No. 2000-16

Official Notification Federal Boat Safety Act Shift Link 3.0 Litre

1999/2000 Model Year 225/250 HP, EFI 200/225 HP, Optimax 3.0 Litre Carb/Work versions S/N 0G927950 thru 0T264046

- a Shift Link Bracket
- **b** Control Cable Attaching Stud
- c Shift Link to Upper Shift Shaft Attaching Stud

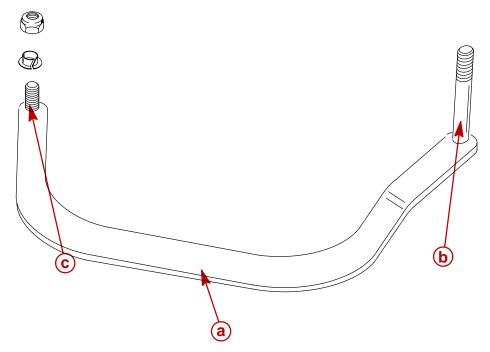
Some shift links may have insufficient weld penetration between the bracket and shift cable attaching stud. This could result in possible attaching stud breakage and loss of shift control.

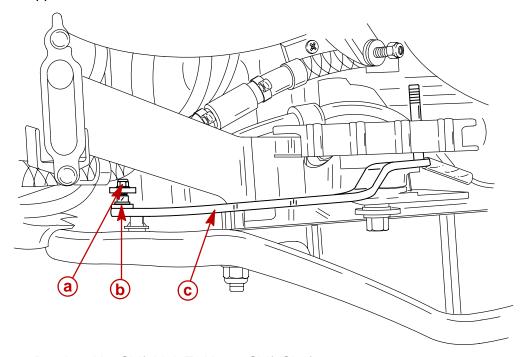
Remove the nut that attaches the shift link to the upper shift shaft, retain the nut and spacer to be reused on the replacement shift link.

NOTE: The view below is shown with the front retainer nut loose and spacer NOT engaged into the upper shift shaft.

- a Retainer Nut Shift Link To Upper Shift Shaft
- **b** Spacer
- c Shift Link Assemble
- Install shift link into upper shift shaft, taking care that plastic bushing enters the shift shaft correctly. Install the nylock nut and drive tight.
- Reinstall shift slide, shift cable, washer, and nylock nut.
- Reinstall the port side bottom cowl, and harness clamp retainer.
